Norban Comtex Ltd. (Extension)

Mouza Sarabo, Chakarborti, Kashimpur, Gazipur

19 February 2024

Observation-1: Stress in column exceeds normal design limit. (Building – 1)

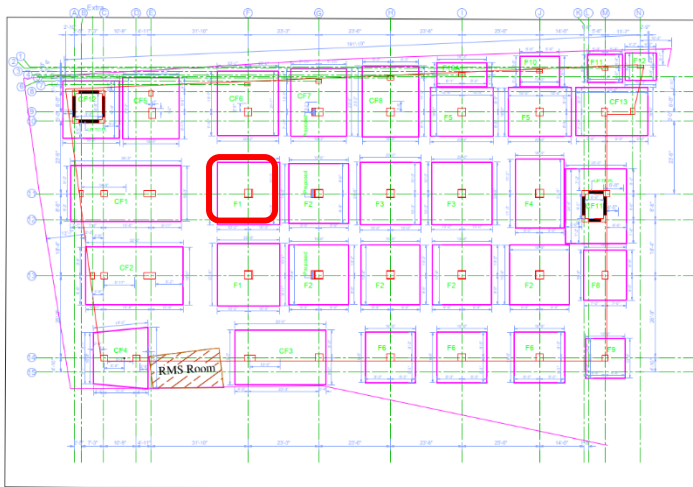
Description: The cursory calculation indicates that the red mark column stress exceeds the normal design limit considering a typical floor live load of 6kPa, roof live load of 1.5 kPa, and minimum concrete strength based on aggregate type. The building engineer is required to review the design, loads, and column stresses for the marked columns based on in-situ material strength.

Observation-2: The foundation found to be stressed. (Building – 1)

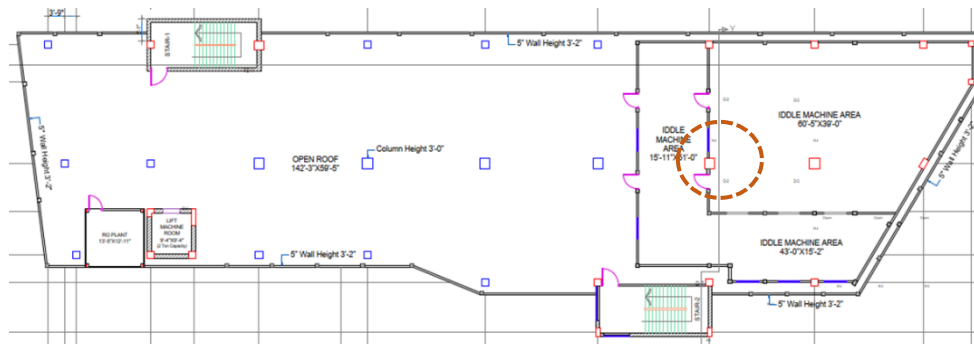
Description: Cursory calculation indicates the highlighted foundation is inadequate for bearing. The loading is considered 6kPa for a typical floor and the allowable bearing capacity of soil is 1.5 tsf (FS: 2.5) at 2.4 m depth. The building engineer is required to verify in-situ material strength and review the design load and foundation stresses.

Observation-6: Stress in the column and foundation exceeds the normal design limit (Building – 4).

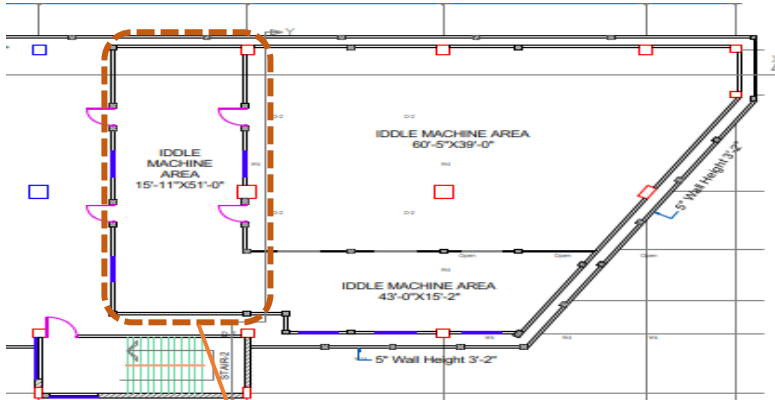
Description: Cursory calculation shows that stress in marked column and pile exceeds normal design limit considering dead load and live load (as per load plan) and minimum concrete strength (16.3 MPa) based on aggregates type, 415MPa rebar strength. The building engineer is required to review the design, load and column stress based on the in-situ material strength by taking a minimum of 4 numbers of 100mm dia. core from the lower tier of the building.
